MEMORANDUM

Spotswood Commons Apartments

**Stormwater Management/BMP
Record Drawing and Construction Certification Review
Tracking Form**

Re: Spotswood Commons Apartments
County Plan No. SP-15-01; Amended SP-82-01
County BMP ID Code: PC 183

Designed: N/A Date: 09/19/02
Checked: PF/SAR Scale: 1"=40'
File Mgr./Drawn: CRO CADD File name: STORMSEWER.DWG
Project Number: 1950040-000.21 Dwg. File No.: 13203AW
Drawing Number: **R-1**
1 OF 3

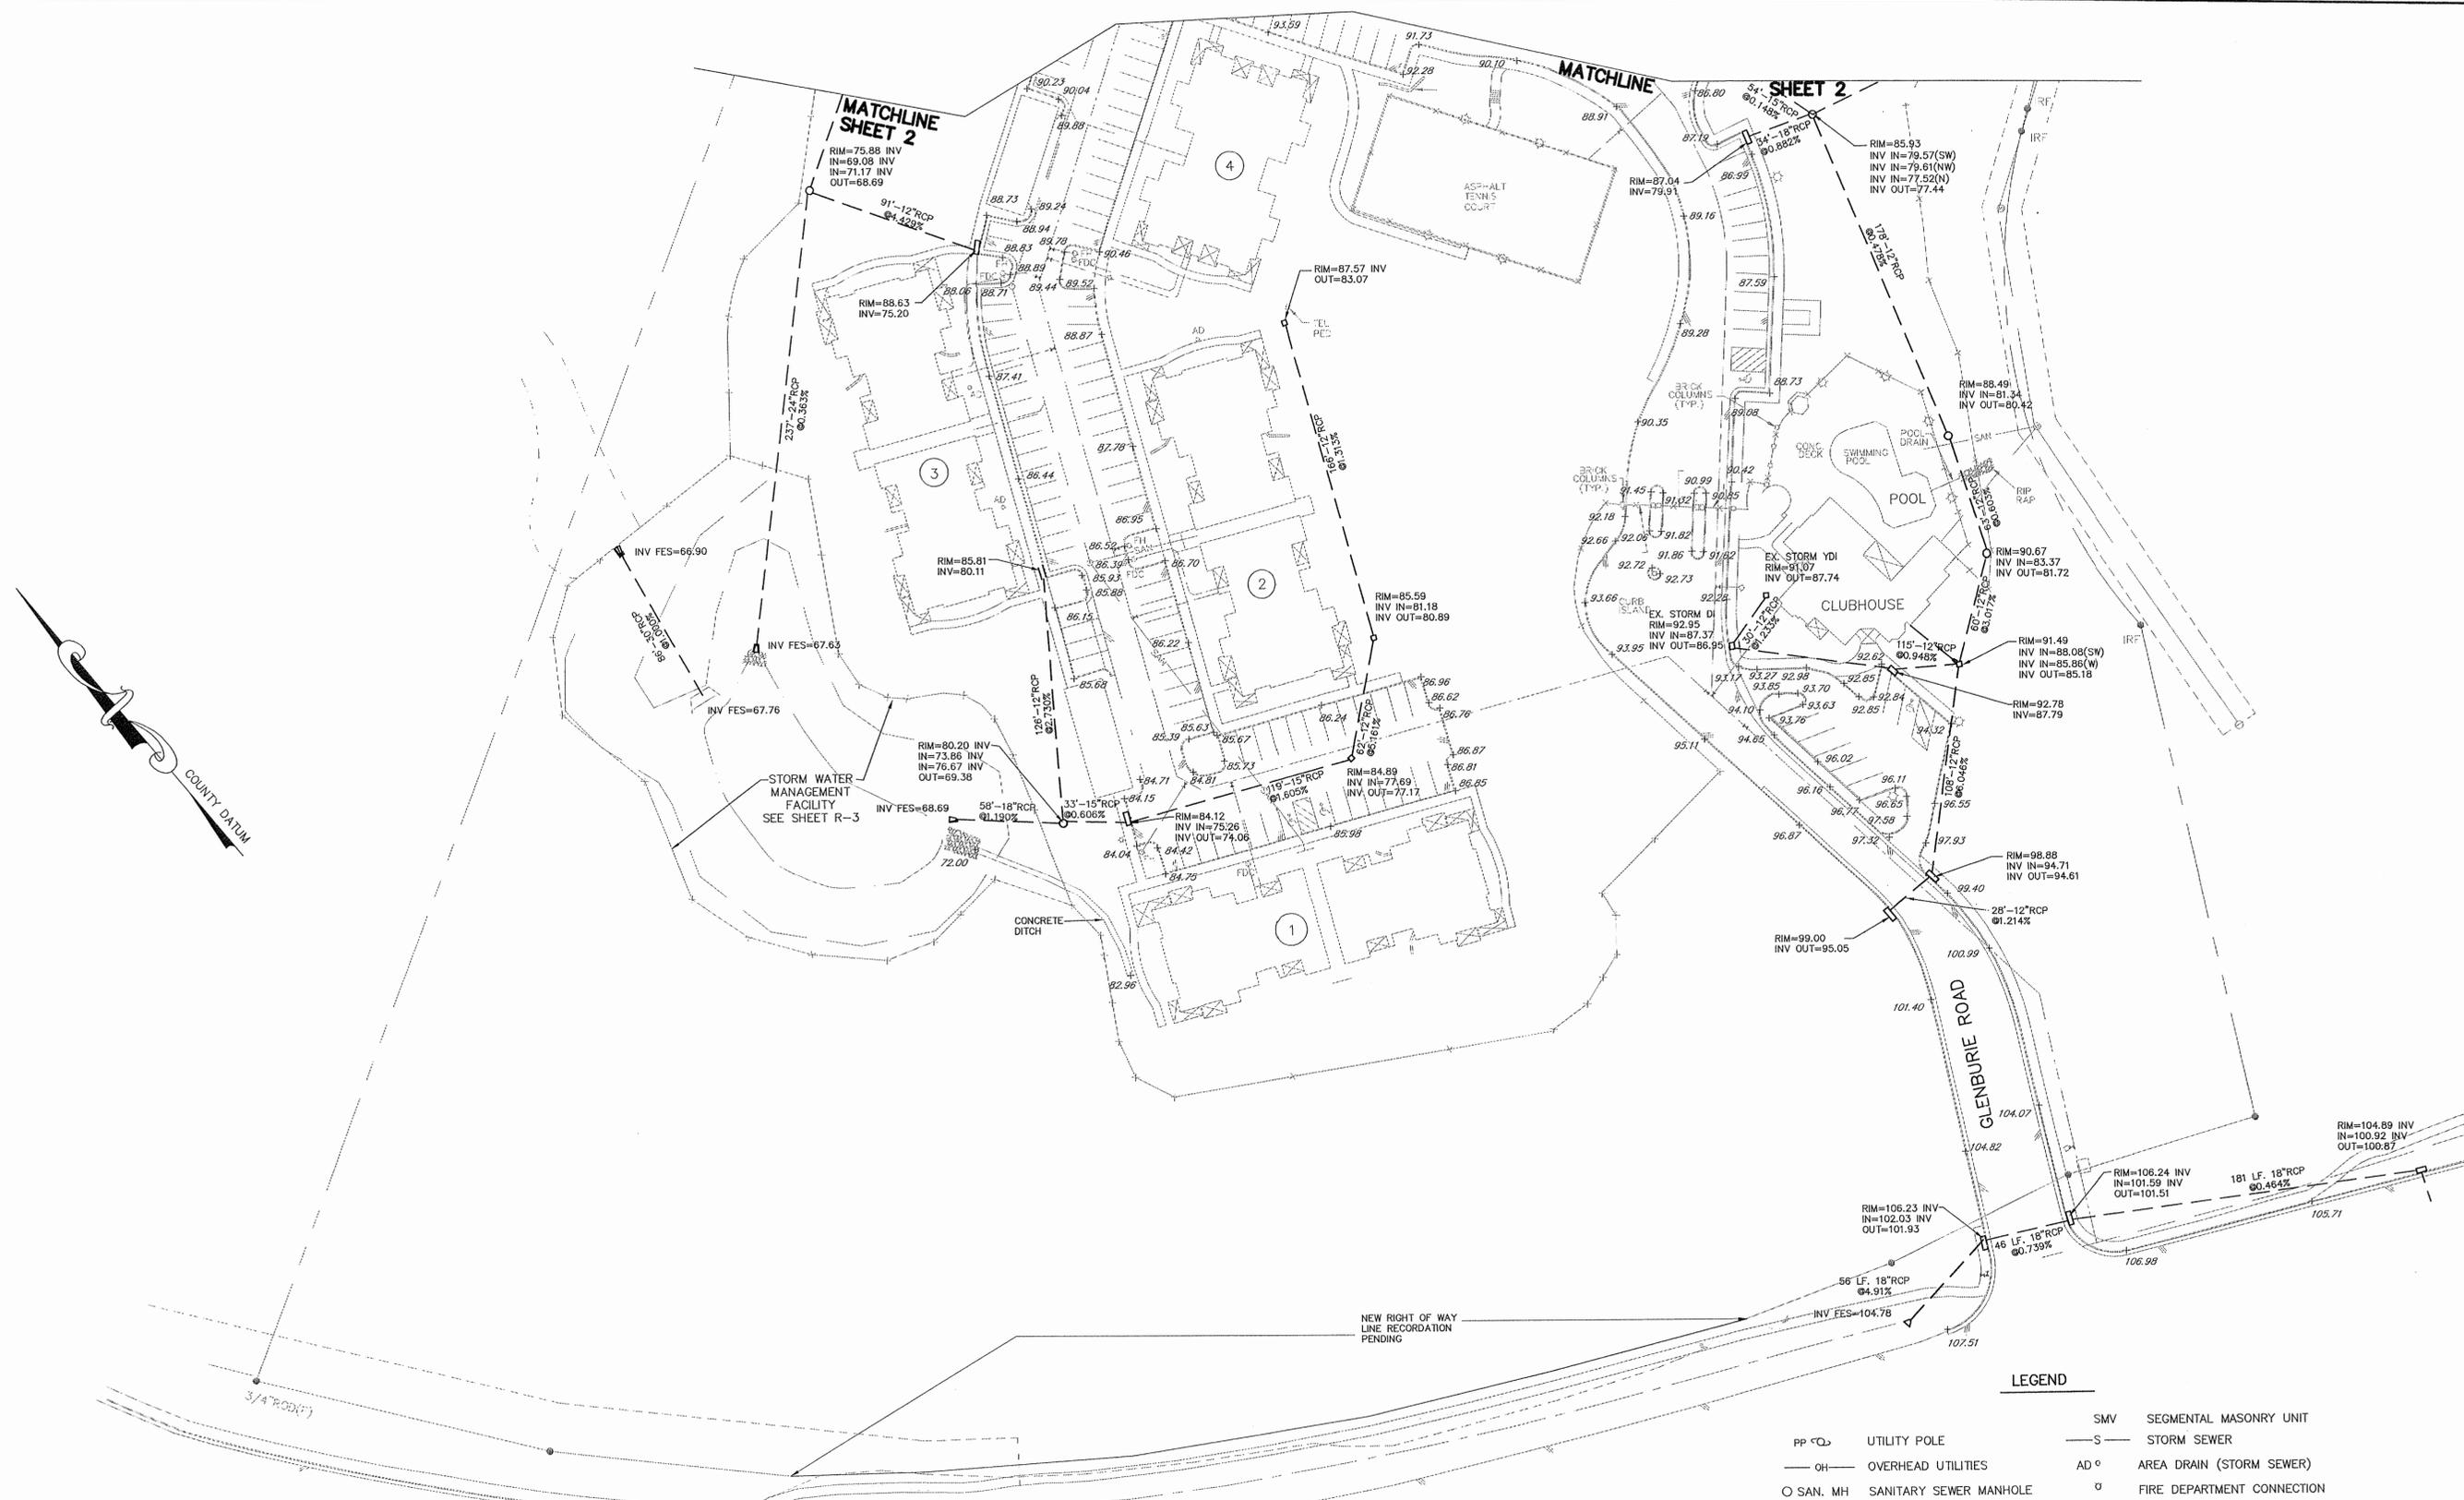
1. A pipe was observed behind the pool outfalling into riprap and toward a denuded easement area. Ensure filter cloth is installed under the riprap and stabilize the denuded easement area with a vegetative cover.
2. Remove sediment and repair riprap at outfall 57.
3. Remove debris/trash from the 90 LF grass swale shown at the end of outfall 57 and stabilize the denuded swale with a vegetative cover.
4. Repair erosion at yard inlet 25 and stabilize with a vegetative cover.
5. A pipe was observed in-between units 13 and 14 outfalling into a denuded area and sediment was observed downslope. Stabilize area where pipe outfalls in-between units 13 and 14.
6. Repair sink hole at yard inlet 2 and stabilize with a vegetative cover.

- Beth* ↓
7. Remove mulch and sediment from yard inlet 17 and stabilize denuded area draining toward yard inlet 17 with a vegetative cover.
 8. Stabilize area draining toward yard inlet 20 with a vegetative cover.
 9. Stabilize denuded slope in-between units 3 and 5 with a vegetative cover.
 10. Repair sink hole at the toe of the slope behind unit 3 and stabilize with a vegetative cover.
 11. Stabilize denuded area on slope adjacent to drainage easement behind units 12 and 13. Sediment was observed downslope.
 12. Remove silt fence and repair erosion in sanitary sewer easement at toe of slope behind parking lot adjacent to unit 12 and maintenance building.
 13. Stabilize denuded area at top of slope adjacent to curb inlet 12 with a vegetative cover.

| Drawing Number | R-3 |

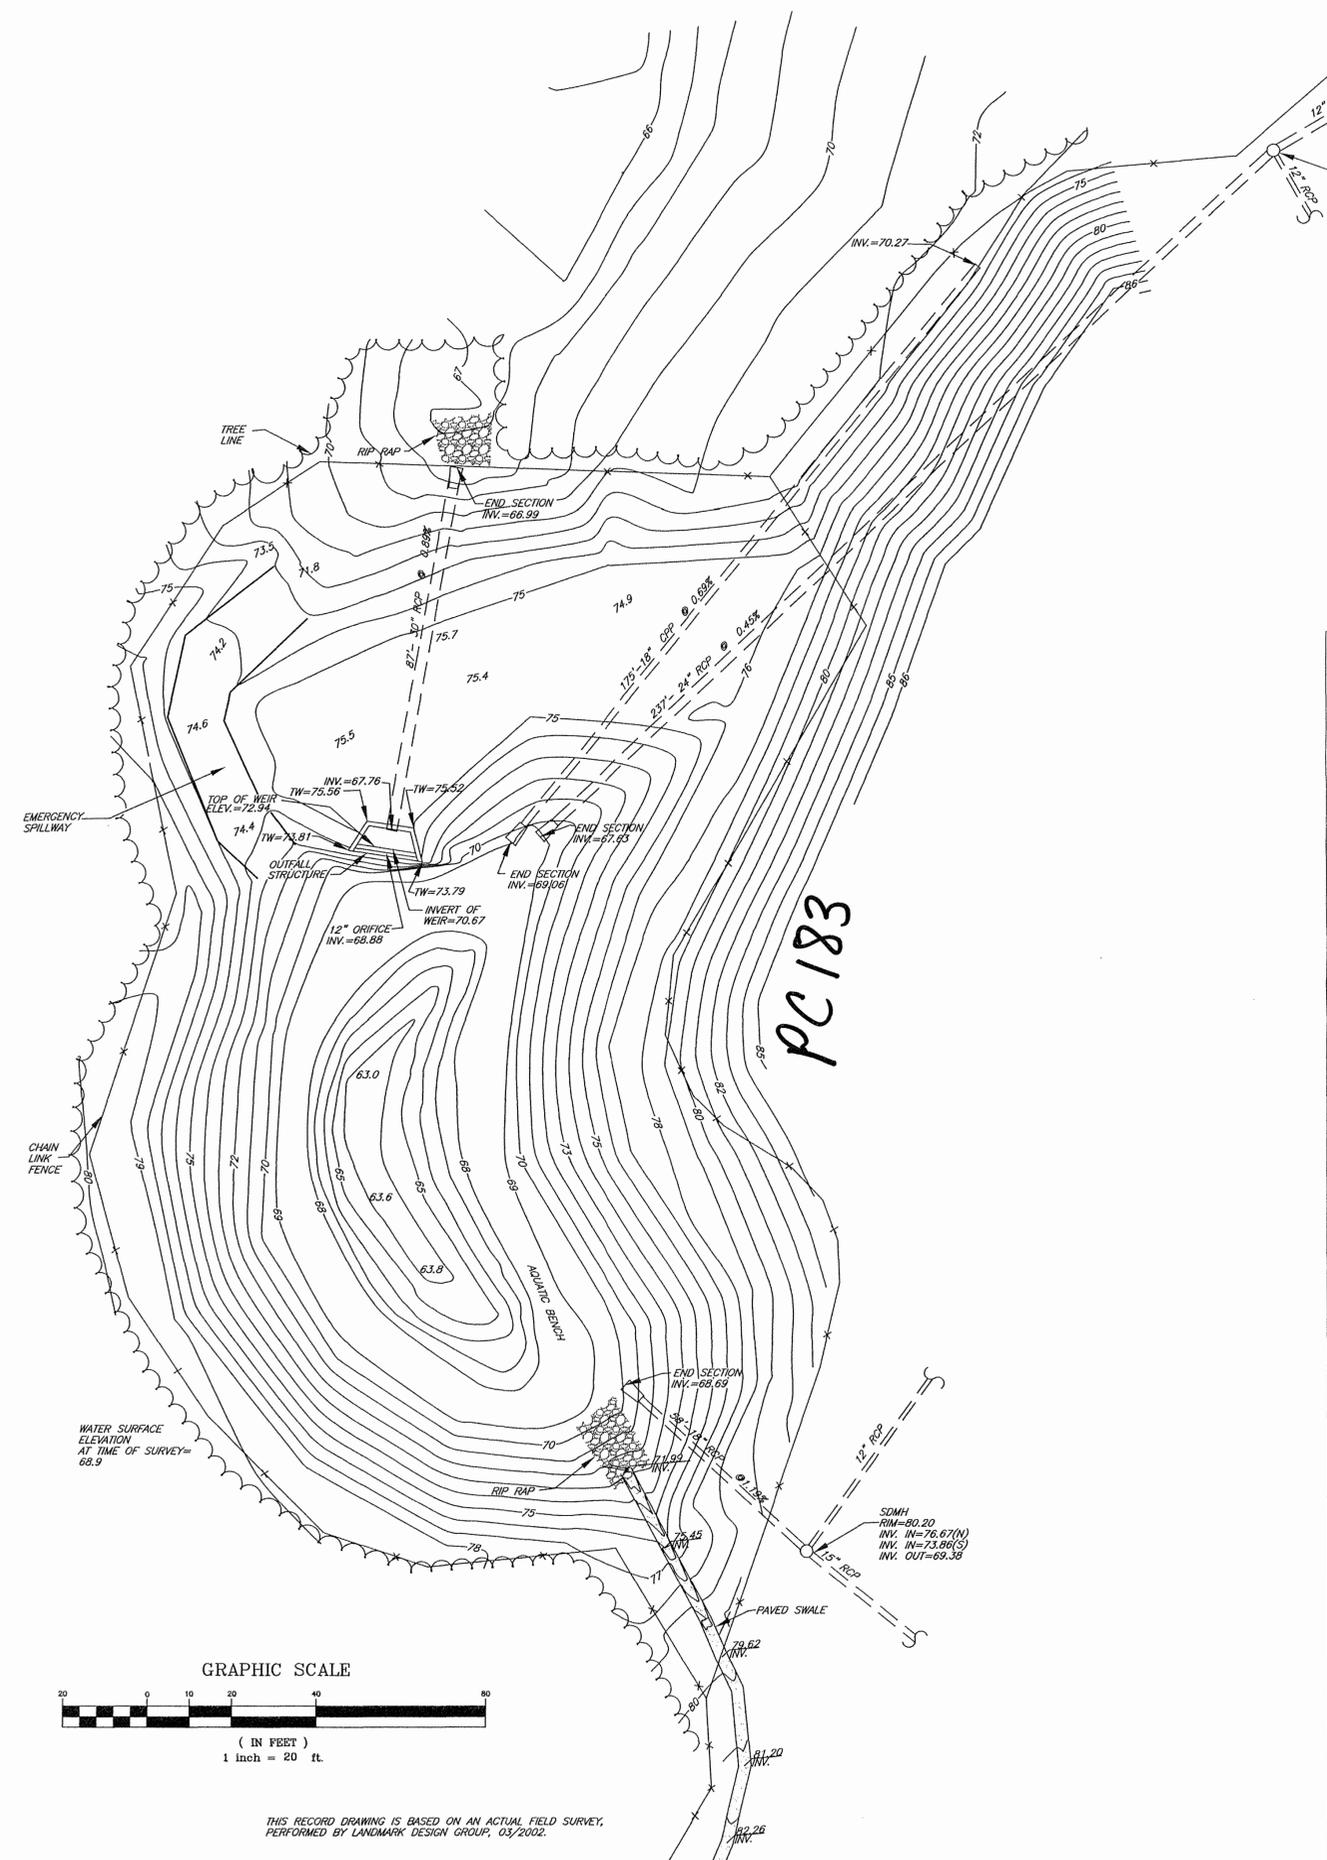
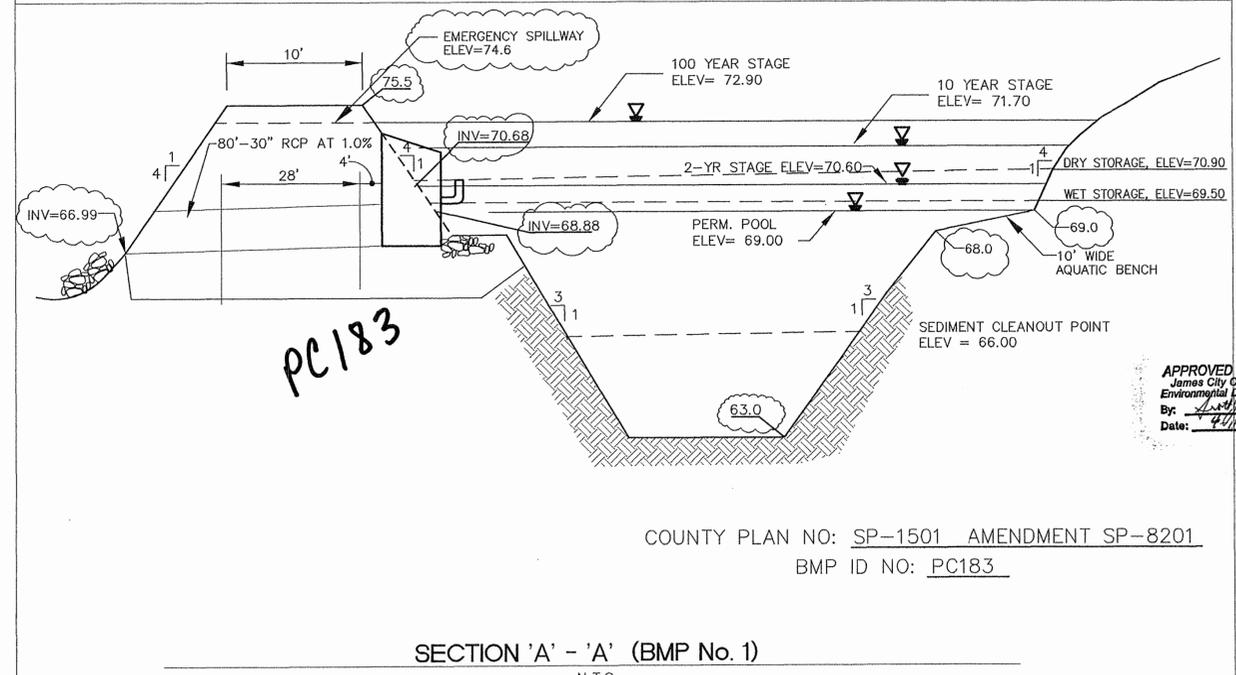
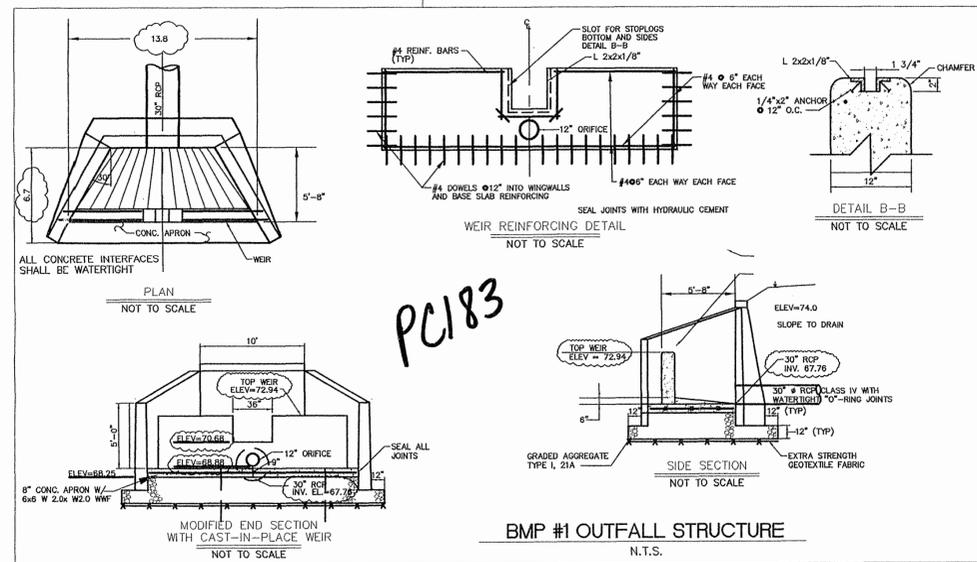
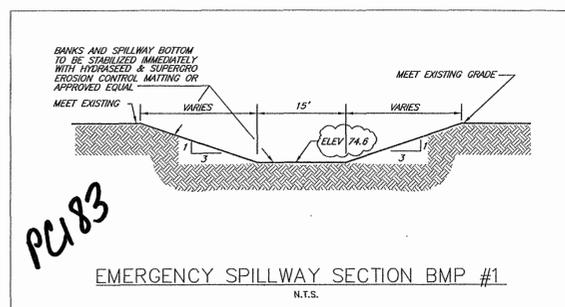
1. In accordance with Note # 19 on Sheet C-10 and various notes on Sheet 5 of the approved plan, construction certification is required for the stormwater management/BMP facility. None was provided. This is especially important since the facility has a large engineered and compacted earthen embankment. The certification can be in letter format or by use of the certification statement as provided in Section 4 of the *James City County, Stormwater Management/BMP Facilities, Record Drawing and Construction Certification, Standard Forms & Instructions*. A copy of these requirements are attached.

Clean and remove all dead wood debris and construction debris (wooden stakes) from the downstream face of the dam.

Clean and remove organic matter (leaves) and debris which has accumulated at the end of the paved flume. The paved flume is situated on an interior graded side slope at the south end of the basin.

Clean and remove sediment accumulations and vegetation within 10 feet of the outfall end of the 18-inch storm drain pipe which enters the basin at the south end of the pond near the paved flume. Sediment accumulation was 4 inches deep within and at the outfall end of the pipe. Sediment also covered most of the outlet protection pad. Flow into the facility shall not be obstructed by sediment and vegetation. Re-establish the outlet protection pad per the approved plan specifications, if necessary.

Riprap ADDED, 24" RCP STILL FULL OF SED MORE THAN 18" NO!
Clean and remove sediment accumulations and vegetation within 10 feet of the outfall end of the 18-inch and 24-inch storm drain pipes which enter the basin at the north corner of the pond. This location is approximately 20 ft. east of the concrete flow control structure. Sediment accumulations were excessive (18 inches deep) at the outfall ends of the pipes and covered most of the outlet protection pads. Flow into the facility shall not be obstructed by sediment and vegetation. Re-establish outlet protection pads per the approved plan specifications, if necessary.

Clear and remove all vegetation, debris and sediment within 10 feet of the front face of the concrete flow control structure where the inlet end of the 12-inch PVC low flow orifice is situated. Also, clean vegetation from inside the 12-inch PVC pipe and clean accumulated stone from within the bottom of the concrete box between the outlet end of the 12-inch PVC low flow orifice and the inlet end of the 30-inch concrete outlet pipe. Flow into the riser and barrel shall not be obstructed by vegetation, sediment and debris.

Clean and remove all trash and debris collected along the fence at the outlet end of the 30-inch concrete pipe barrel through the dam. It appears the chain link fence which spans across the natural channel just downstream of the outlet end of the pipe barrel is trapping a considerable amount of debris. The fence should be cut to at least the top height of the 30-inch pipe to allow free-flow out of the basin. Flow out of the basin shall not be obstructed by structures, trash and debris.

To prevent unauthorized access, add a padlock to the gate situated at the south corner of the basin near the parking area to the south of Building Unit # 3. Provide an extra set of keys or combination for the lock to the Environmental Division office.
